From: Rob Wilson
 To: "Kirsten Dell-Hartgers"; Garry Van der Krogt
 Cc: Margaret Waller; Les Wilson
 Subject: RE: Cashmere High - id 340 - monthly fire alarm and sprinklr testing
 Date: Monday, 11 February 2019 6:21:37 p.m.
 Attachments: [REDACTED]

Subject: Fire Systems failures

Response to building warrant fitness inspection by Argest on 20 June 2019.

SITE PLAN

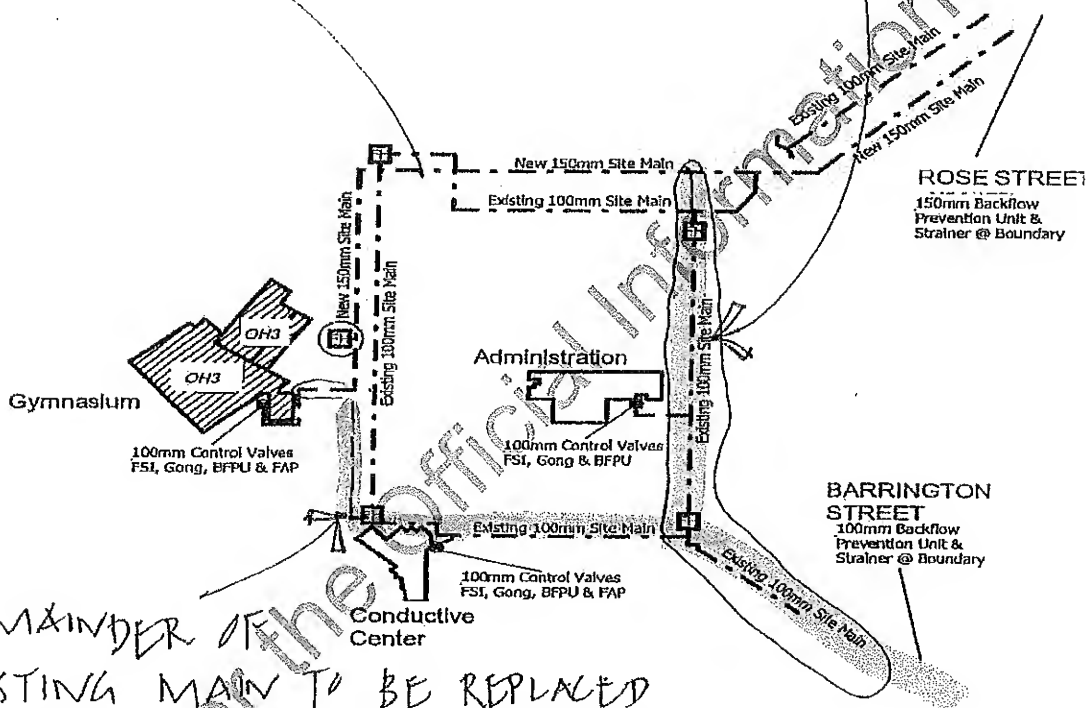
* ATYFIELD ARCHITECTS
COMMENTS 15/06/17.

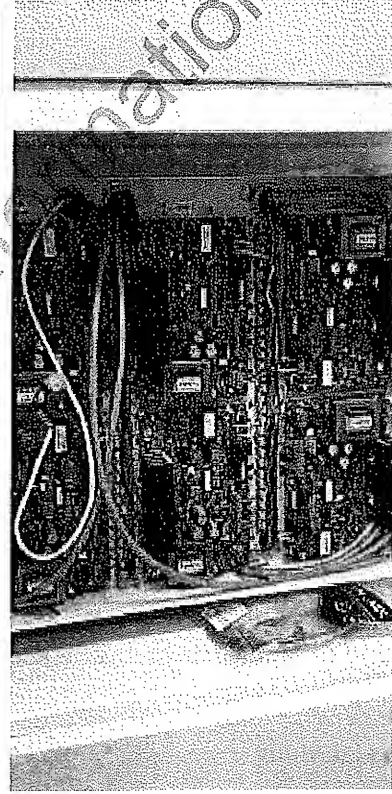
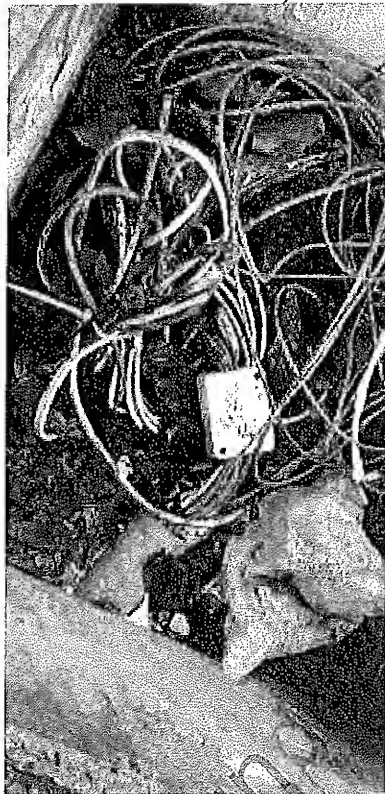
5. Sounder fault on Amp 4 needs attention as this is causing a fault on the panel. We carried out fault finding on evacuation circuit for Amplifier 4. The fault tended to come and go. We tracked it back to some underground junctions that were inadequately terminated. These junctions were temporarily made good and the fault cleared. No sign of a fault on this Amplifier has since occurred. The temporary junction will not cause issue but will require a permanent water protected join which we will look at doing week starting 15 July 2019 during School Holidays. Photo 1 shows underground junction with inadequate water protected terminations. Photo 2 shows another major junction on the side of the Administration Block which also required improved terminations. Photo 3 shows ALL Amplifiers in normal state (defect state shows a bright yellow LED on the left of the board).
